REPORT NO. 10CFR21-0063  
JANUARY 25, 1993

10CFR21 REPORTING OF DEFECTS  
AND NON-COMPLIANCE

COMPONENT: Automatic Drain Float - Balston 21554-1  
Air Piping Filter Assembly - A912A-DX and A913A-DX

SYSTEM: All A912A-DX and A913A-DX Air Filters Manufactured  
prior to November 1989

BALSTON AIR FILTER DRAWINGS - P/N A912A-DX  
- MARCH 1989 DESIGN  
- NOVEMBER 1989 DESIGN

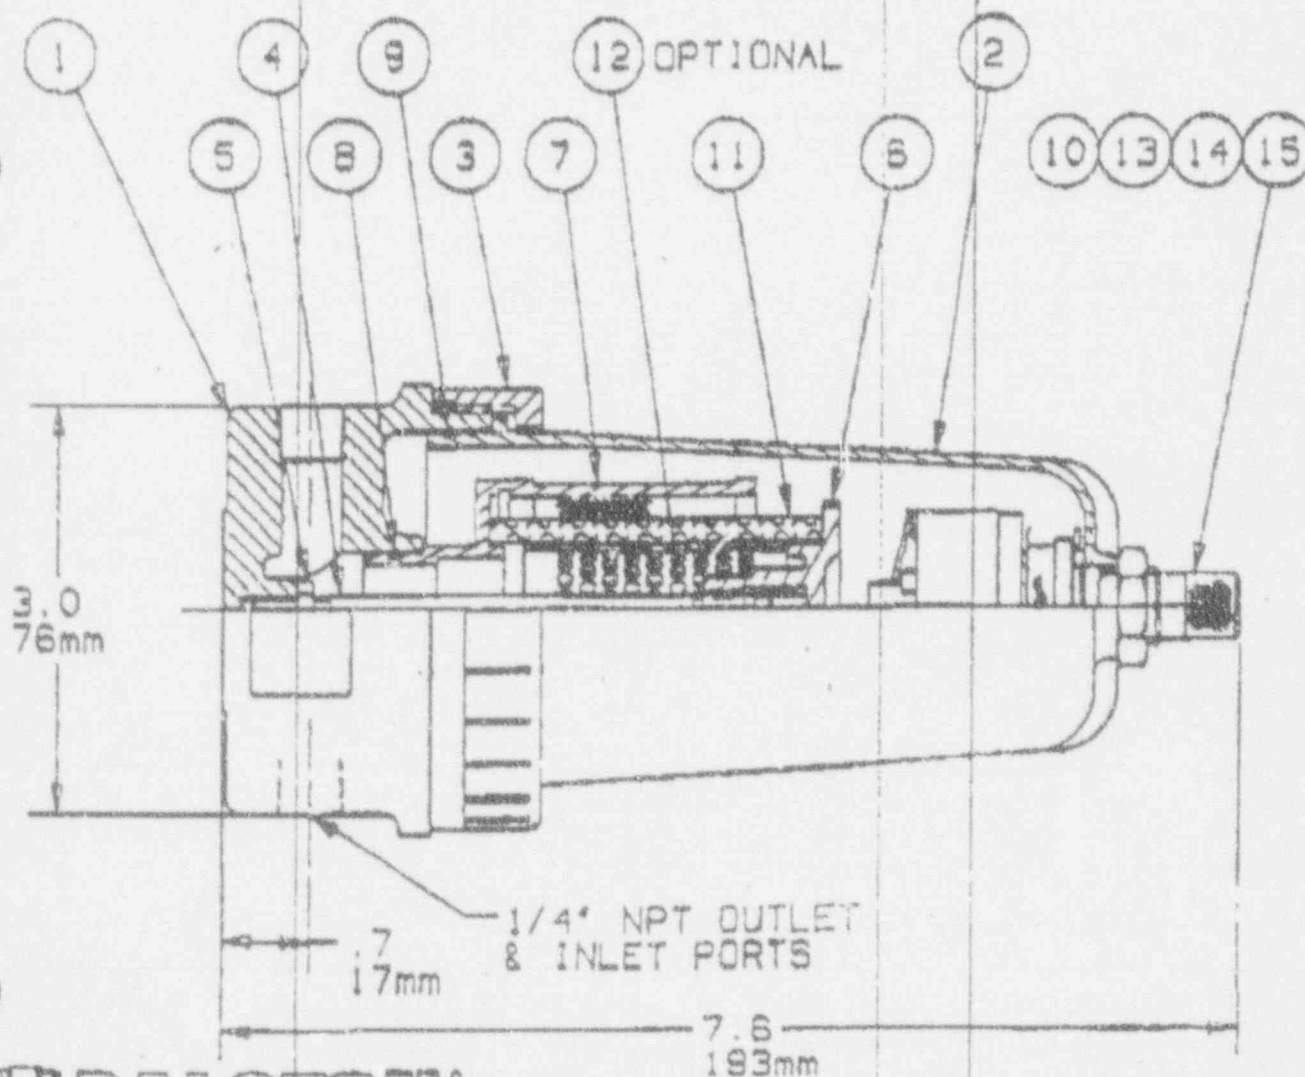
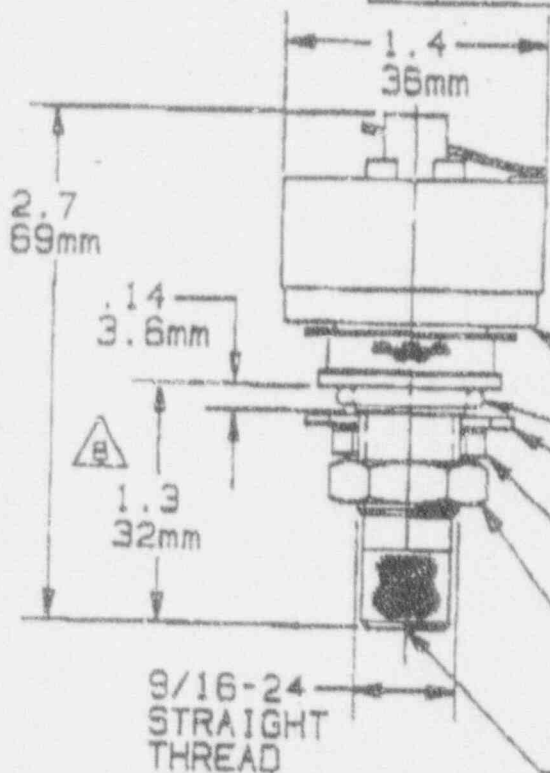
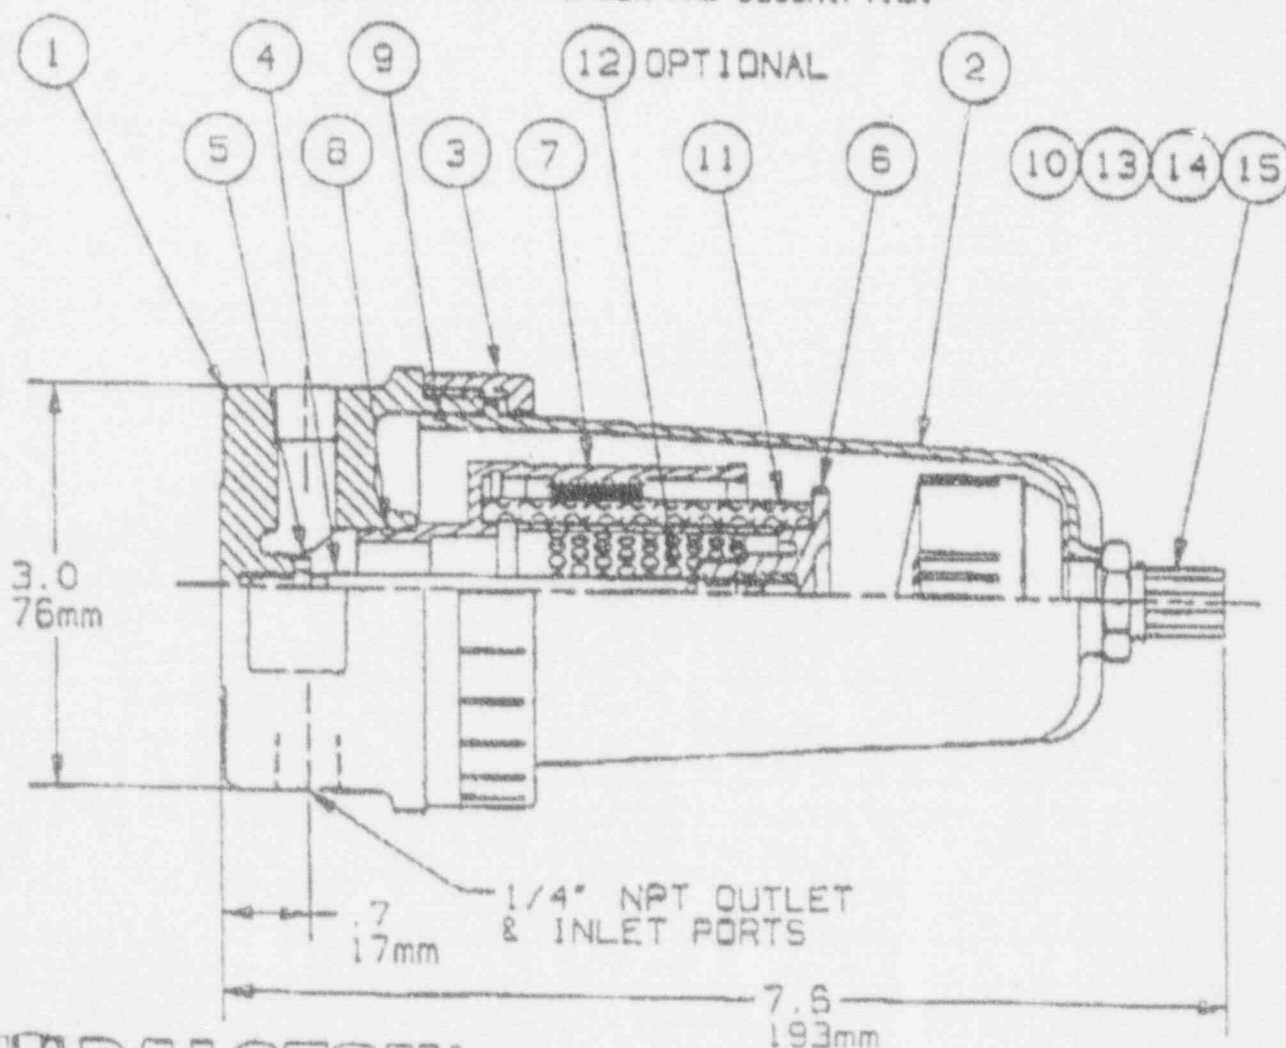
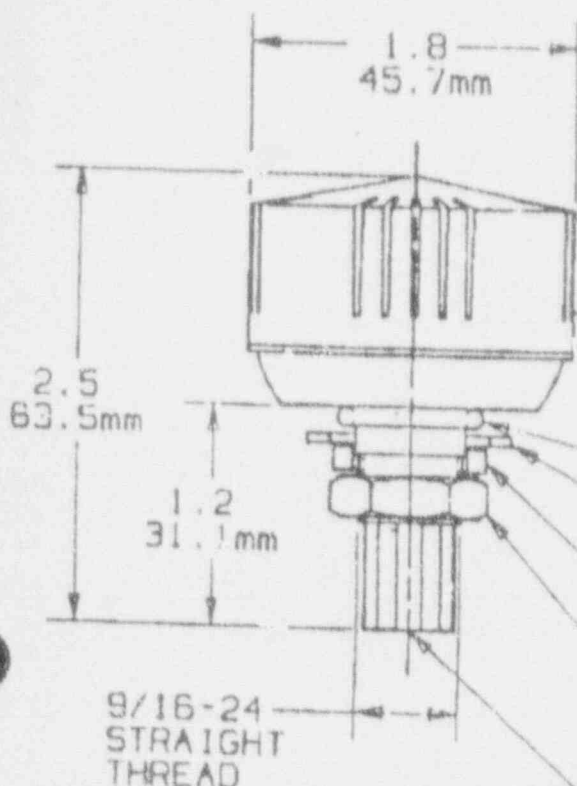
The material that the drain float was made of disintegrated when exposed to the elements in the air start piping system.

The maintenance engineers at Duquesne Light discovered the potential problem during routine maintenance, and it did not cause a start system failure. The particles were isolated in the filter housing which suggest that the material degradation was caused by contaminants in the air start system. These contaminants could possibly have an adverse effect on the material; causing the rubber to break down when exposed in the system. Balston implemented a material change to the drain float in November, 1989, where the material was changed from a rubber composition to plastic (see Exhibit 2). The new floats have been installed in the system and there have been no problems detected.

Customers should order the air filters manufactured after November, 1989, which consists of the 21552-2 automatic drain float made of plastic. This design has been shown to withstand contaminants that enter in the air start system.
